Re: Normandy Heights Plat Wetland and Fish and Wildlife Habitat Assessment Report—Third Party Review

Confluence Environmental Company (Confluence) has reviewed the wetland and fish and wildlife habitat assessment report (the critical areas study report) submitted by Soundview Consultants (Soundview) for the Normandy Heights Plat project (PLPMP20220090) located at 2007 Shaw Road, Puyallup Washington (Parcel 0420354039) (Soundview 2022).

Figure 1. Location of CEC-1 and possible wetland area

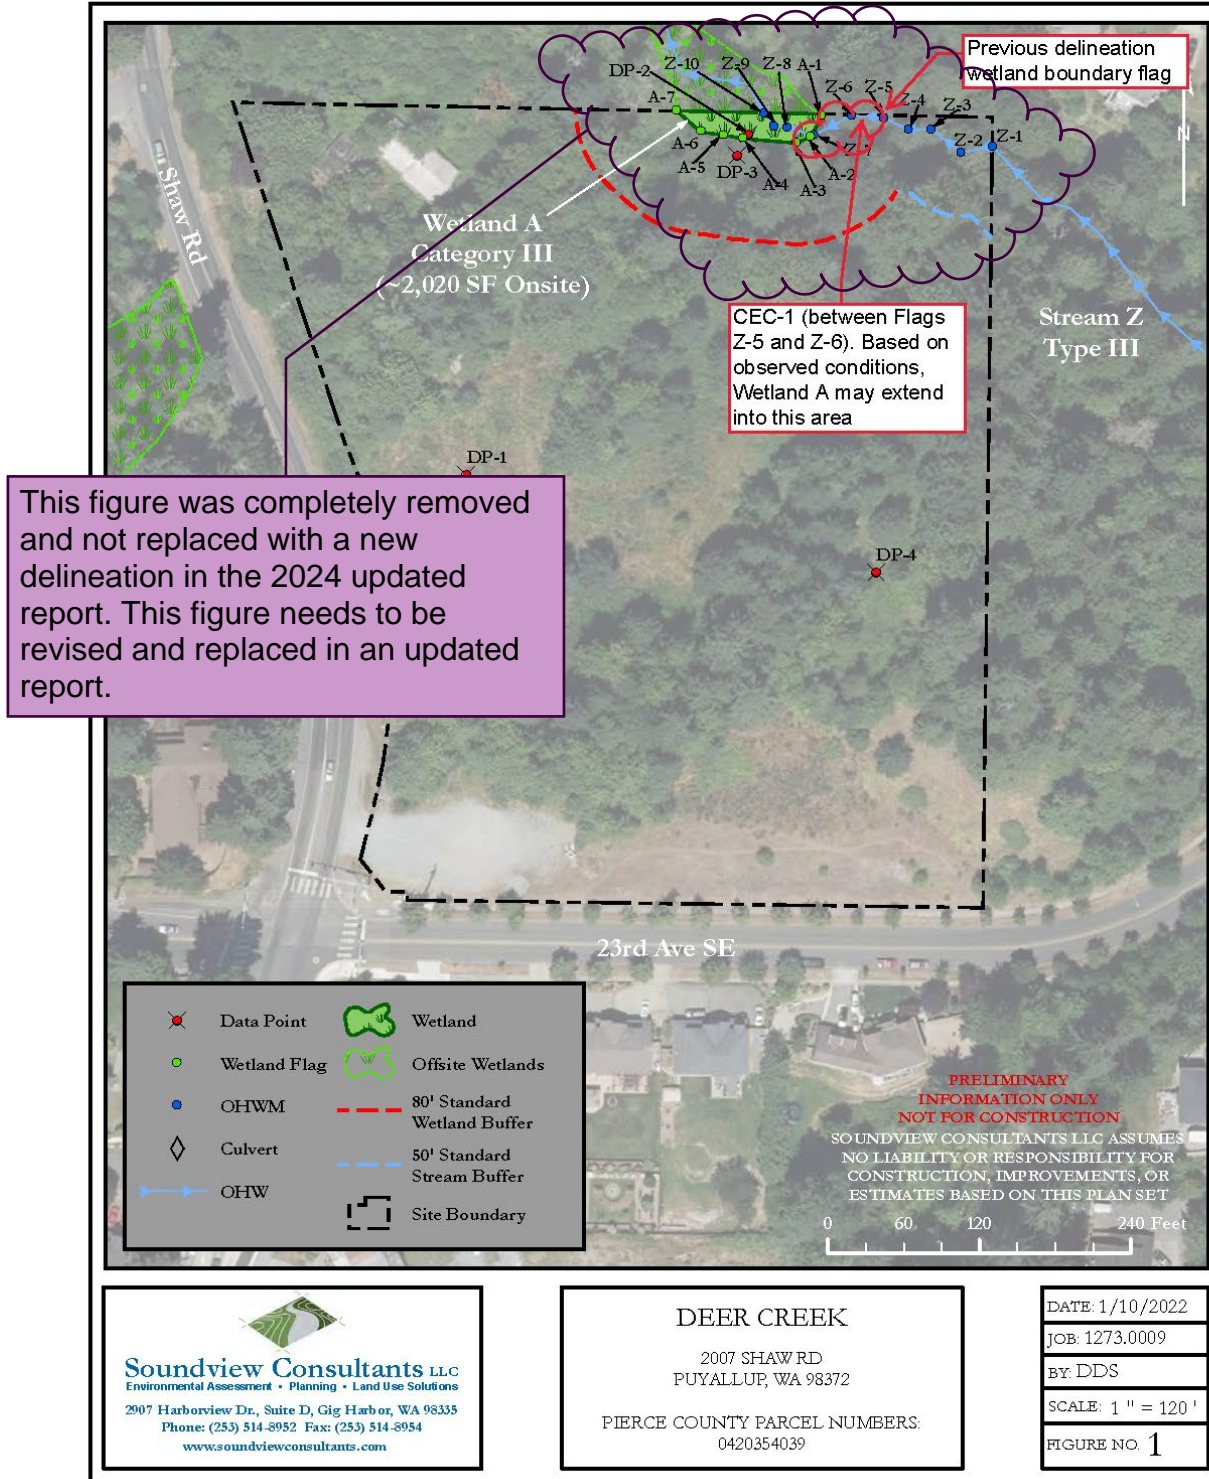
During our field investigation, we observed wetland characteristics east of the delineation boundary flags A-1 and A-2. Additionally, we found an old wetland delineation boundary flag attached to the northeastern site boundary fence line at Flag Z-5. The flag was not labeled with a date or company name. Confluence dug a soil probe labeled CEC-1 on the south side of the stream between Z-5 and Z-6 (Figure 1). Confluence observed several plant species of facultative (FAC) and obligate (OBL) listings, including the following: skunk cabbage (*Symplocarpus foetidus*) (OBL), piggy-back plant (*Tolmiea menziesii*) (FAC), water-parsley (*Oenanthe sarmentosa*) (OBL), salmonberry (*Rubus spectabilis*) (FAC), and lady fern (*Athyrium filix-femina*) (FAC). Presence of these species meets the hydrophytic vegetation criterion. Saturated soils were observed at 9-10 inches below ground surface, with groundwater coming into the test pit at 10 inches, thus meeting the wetland hydrology criterion. Soil in the top layer (0-11 inches) was as 10YR 2/1 silt loam.

This figure was completely removed and not replaced with a new delineation in the 2024 updated report. This figure needs to be revised and replaced in an updated report.

Confluence did not dig past 11 inches, but assumed that A11—Depleted Below Dark Surface or A12—Thick Dark Surface are possible given the 10YR 2/1 soil color and depth. Otherwise Confluence agrees with the wetland boundary between Flags A-2 through A-7 and the approximated off-site boundary.

- Reassess and revise the delineation of Wetland A to include the wetland area to the northeast of the stream and update the field-flagging to extend to the site boundary and wetland boundary flag attached to the fence. Update the report and appendices C, D, and E accordingly.
- Update the Appendix F – wetland rating form sections H1.1 H1.2 and H1.4 for Wetland A as described above. Please note that this may also result in an increase in wetland buffer widths.
- Update the report to provide data on OHWM widths and clarify if the buffer was measured from the centerline or the OHWM. Please include photos showing the OHWM.
- Update the report and change the stream typing from Type III to Type II.
- Update site plans to depict changes in wetland size, wetland category, stream type, and associated buffers.

DEER CREEK - HABITAT MAP

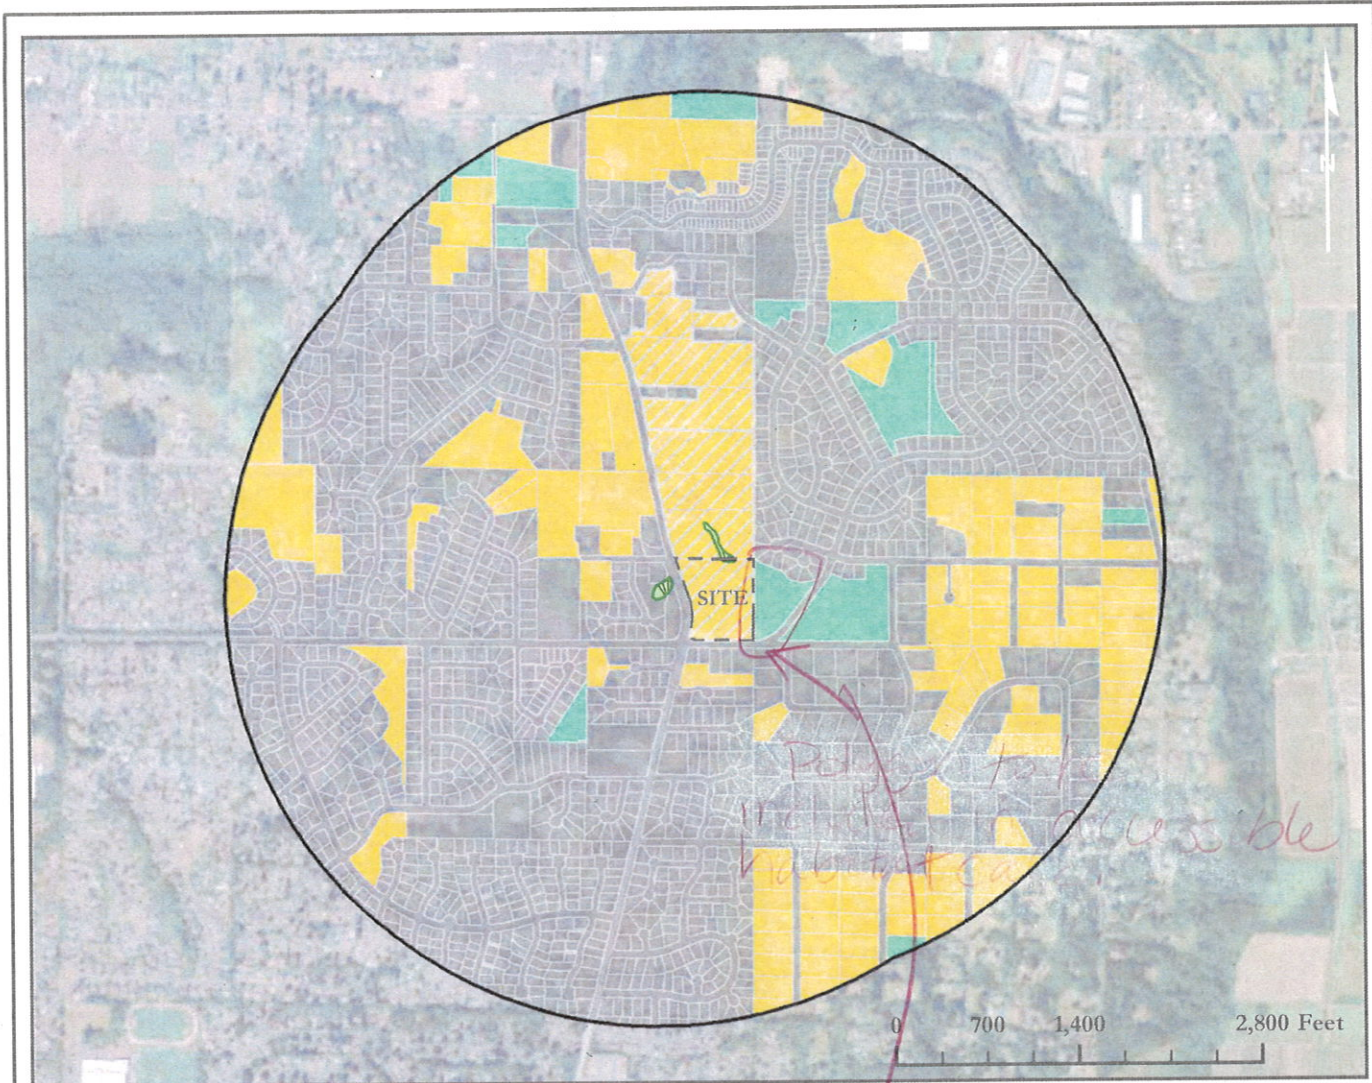
Handwritten note: polygon should be included in accessible habitat calc. because there is no human disturbance between polygon + wetland
